Project  
**THE WEST MIDLANDS RAIL FREIGHT INTERCHANGE ORDER 201X**

Drawing Title  
**ACCESS AND RIGHTS OF WAY PLAN SHEET 6 (INSET D AND E TO SHEET 1)**

Document  
2.3F

Drawn NW Date: JUNE 2018 Scale 1: 1000 Reviewed JF  
Drawing No. WSP-70001979-SK-060 Rev. F

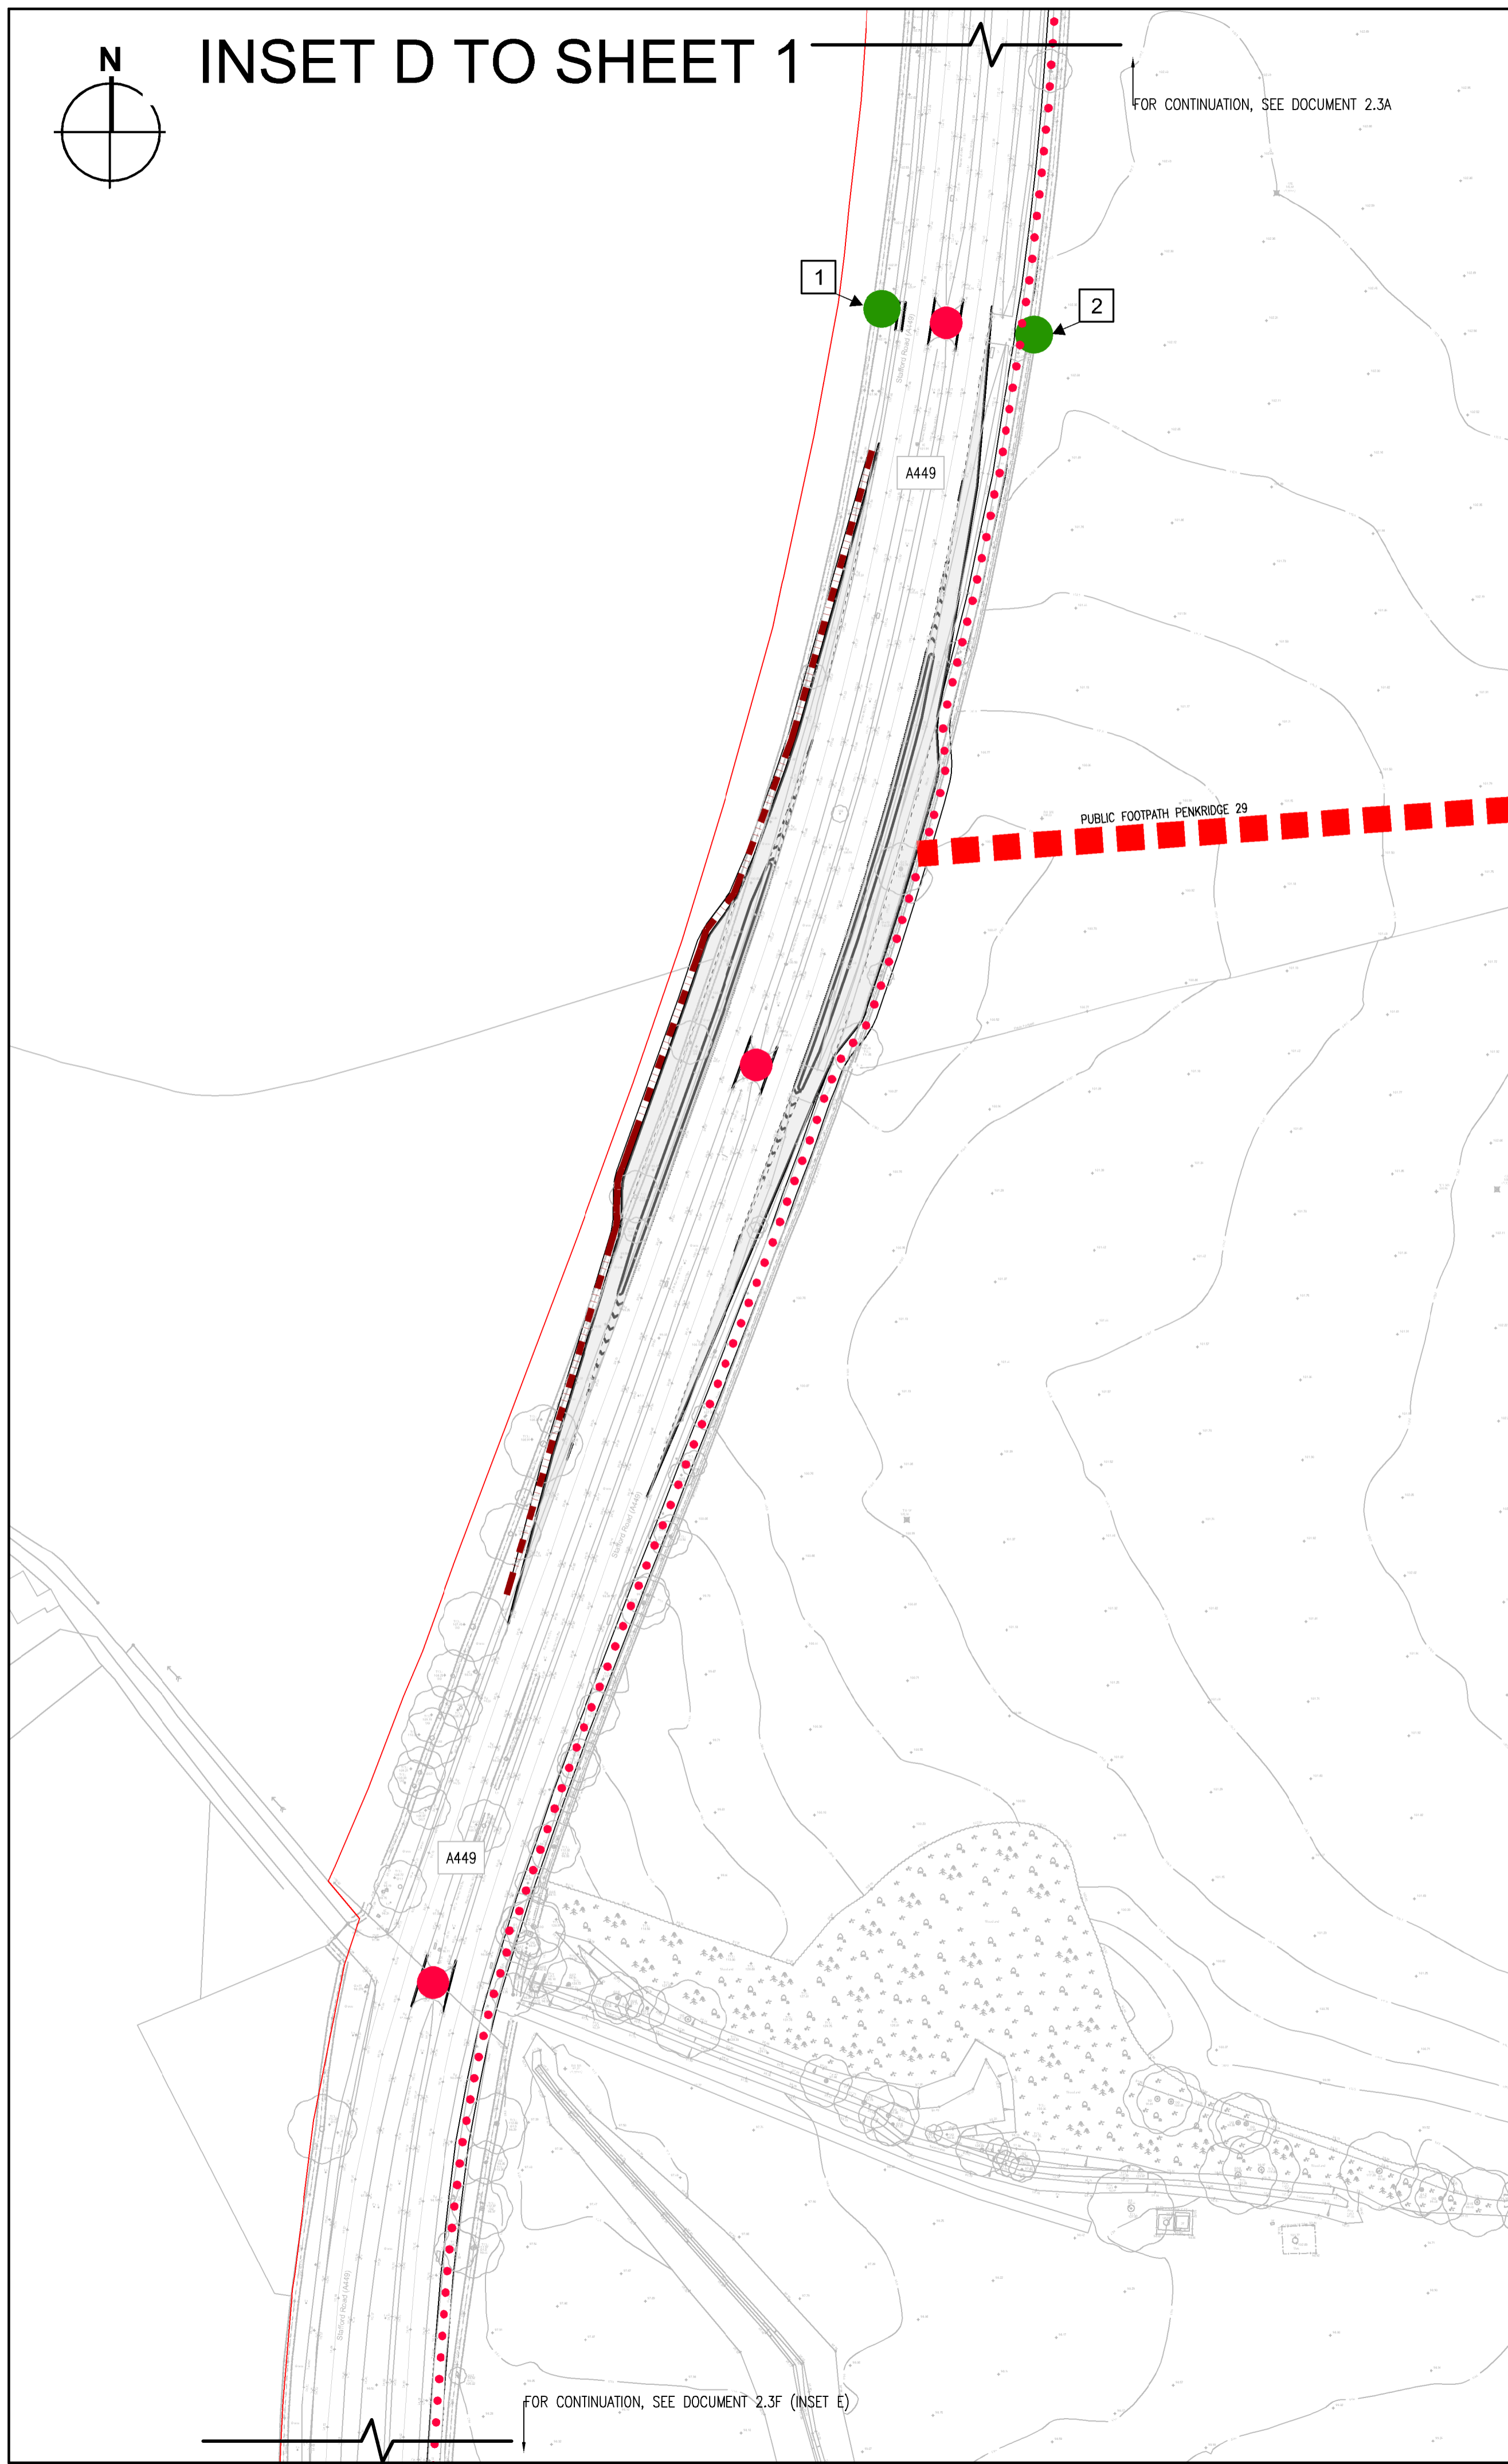
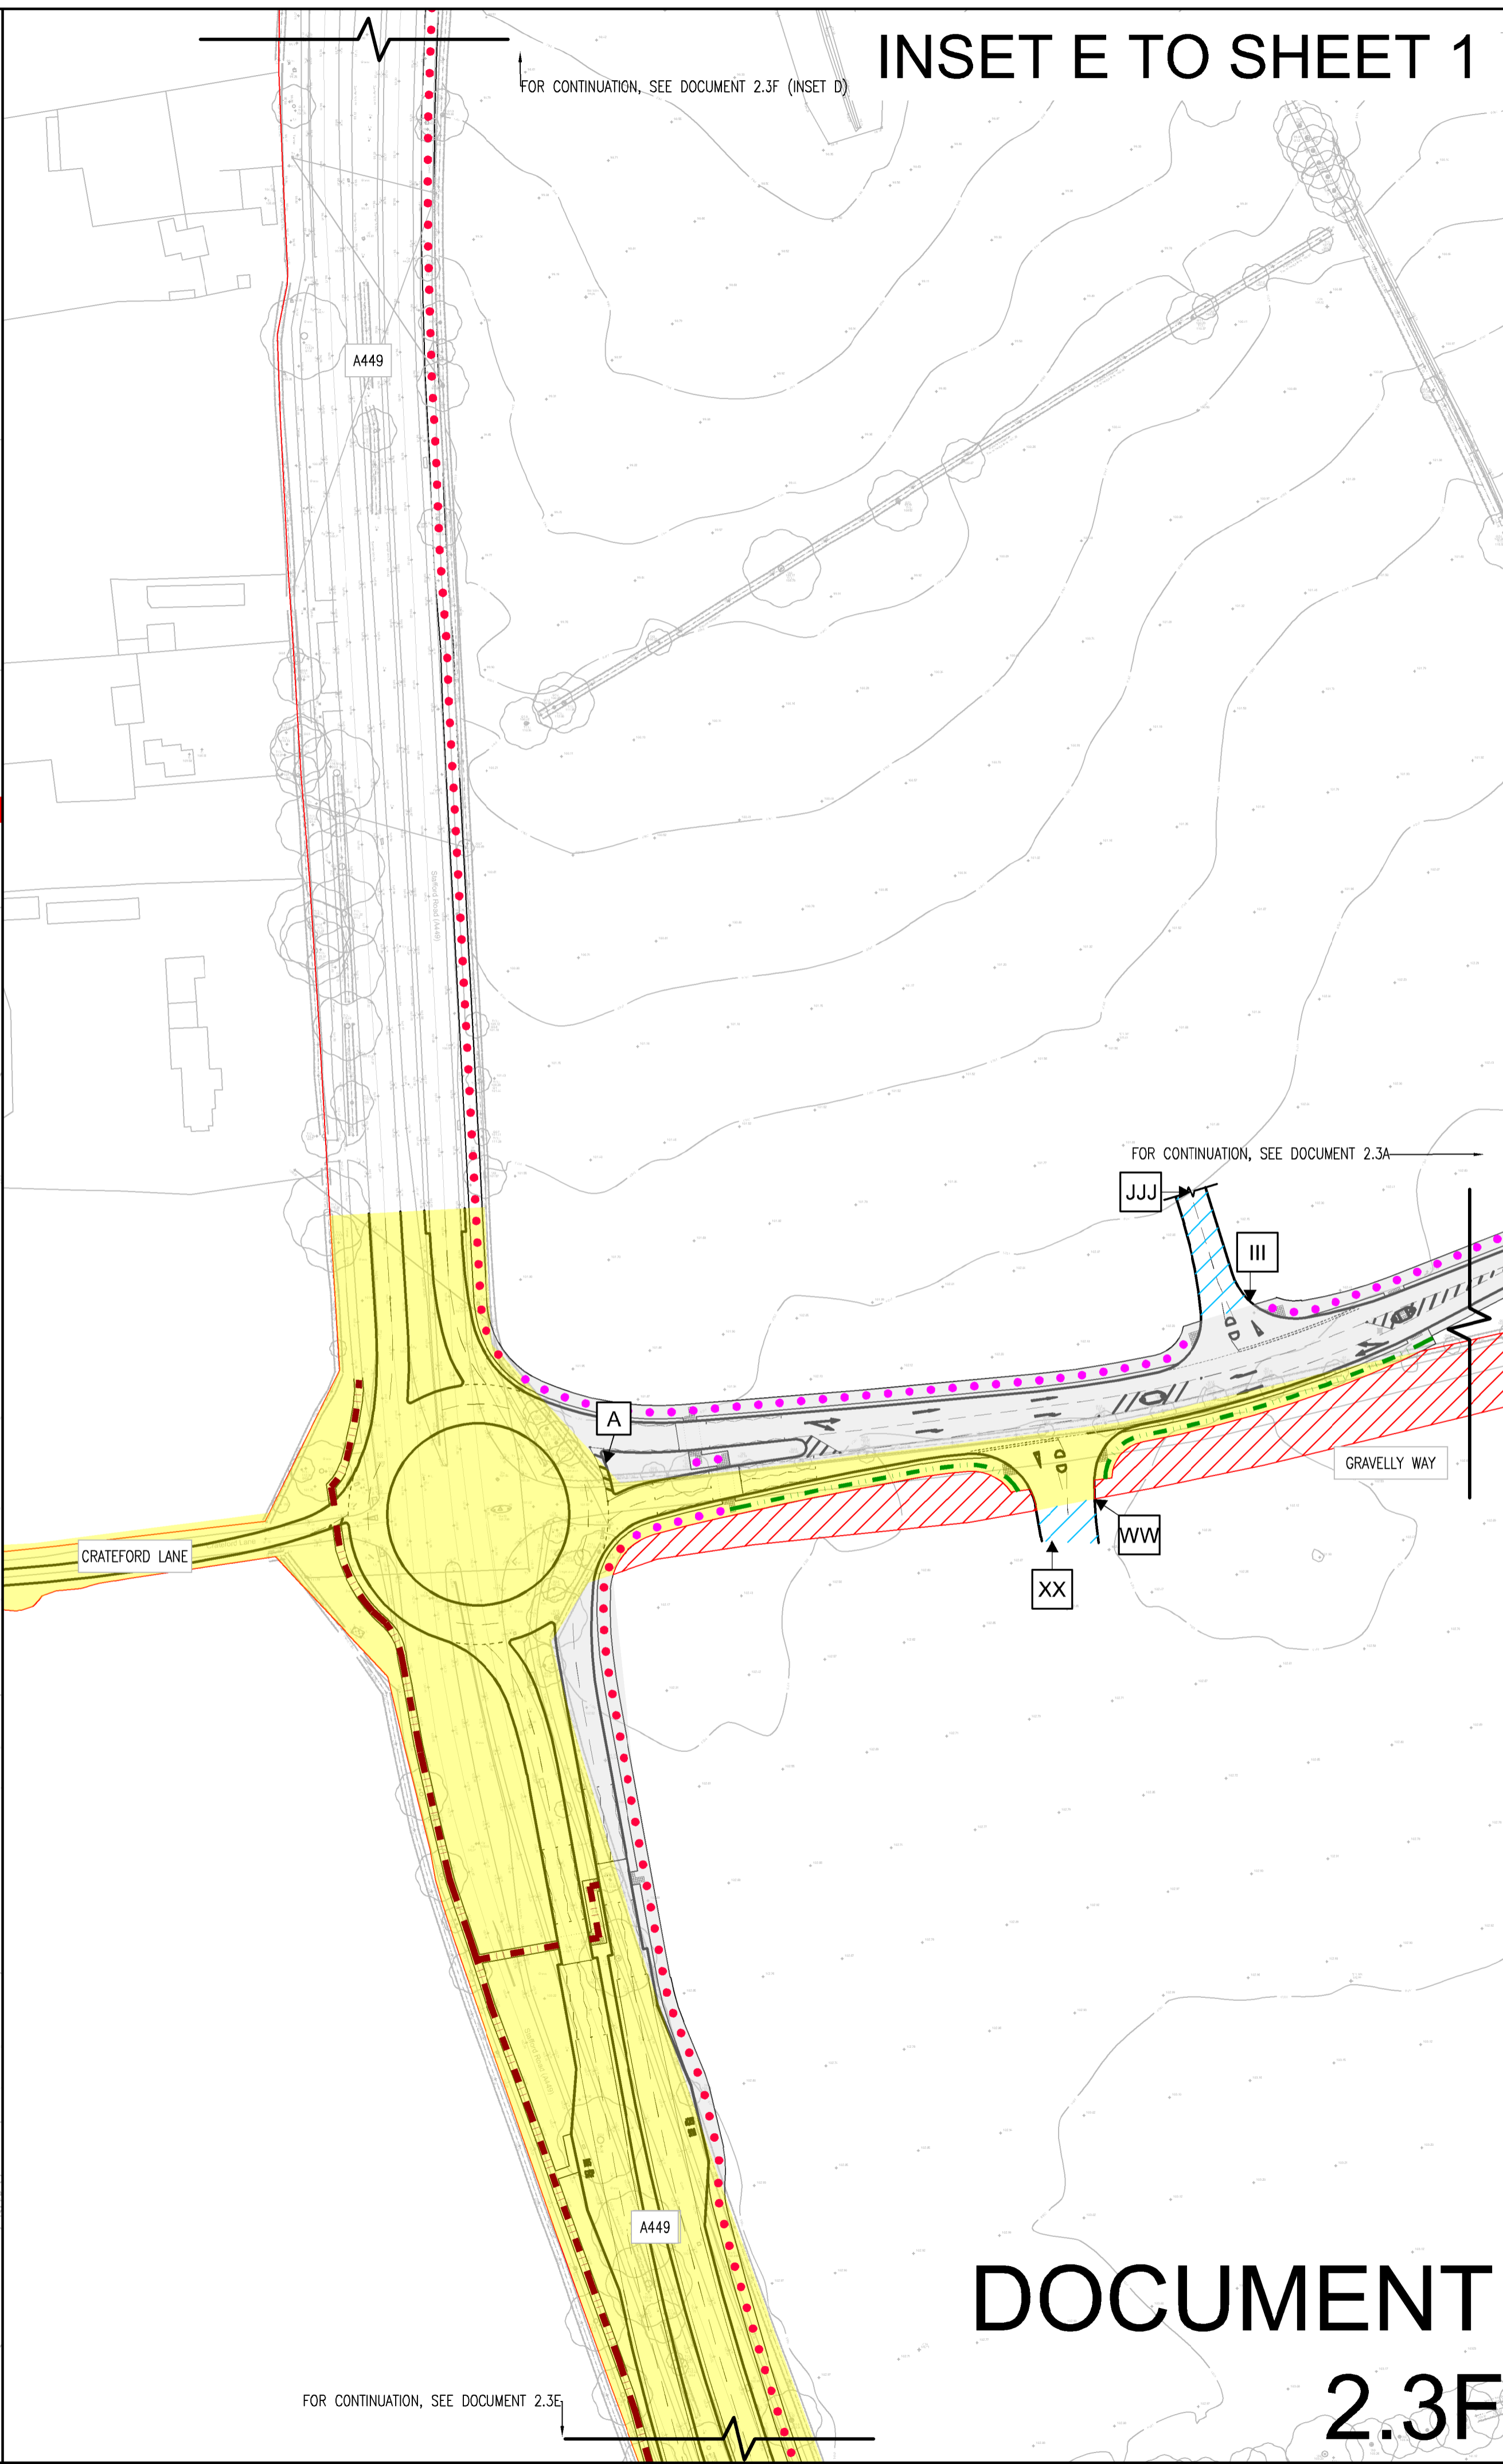
- MAY 2019**
- PEDESTRIAN CROSSING ON THE A449 SIGNALISED AND RELOCATED FURTHER SOUTH OF THE ROUNDABOUT IN RESPONSE TO COMMENTS FROM HIGHWAYS ENGLAND IN RSA.
  - PEDESTRIAN CROSSING ON GRAVELLY WAY MOVED EAST, STAGGERED AND SIGNALISED IN RESPONSE TO COMMENTS FROM HIGHWAYS ENGLAND IN RSA AND AS A RESULT, THE ACCESS TO THE RAIL TERMINAL HAS BEEN MOVED EAST. THE TOTAL WIDTH OF THE GRAVELLY WAY ARM HAS BEEN INCREASED TO PROVIDE SUFFICIENT WIDTH FOR THE CROSSING AND VEHICLE MOVEMENTS.
  - FOOTWAY WEST OF THE A449 HAS BEEN RELOCATED AND RECLASSIFIED AS CYCLEWAY / FOOTWAY IN RESPONSE TO COMMENTS FROM HIGHWAYS ENGLAND IN RSA.
  - ADDITIONAL VERGE ON THE EASTERN SIDE OF THE A449 HAS BEEN ALLOCATED TO ENSURE VISIBILITY TO THE PEDESTRIAN CROSSINGS IS PROTECTED.

- JULY 2019**
- LABELS REMOVED TO REFLECT SCC REQUEST THAT CERTAIN FOOTWAYS / CYCLEWAYS ARE NOT IDENTIFIED AS NEW PUBLIC RIGHTS OF WAY.
  - PEDESTRIAN CROSSING OF WESTBOUND GRAVELLY WAY POSITIONED FURTHER WEST IN RESPONSE TO HIGHWAYS ENGLAND COMMENTS AND RSA.
  - CROSSING AREA ON CENTRAL ISLAND OF GRAVELLY WAY REVISED.

- AUGUST 2019**
- AMENDMENT TO CROSSING ON LINK ROAD IN RESPONSE TO COMMENTS FROM RSA AND 02104 SAFETY RISK ASSESSMENT.
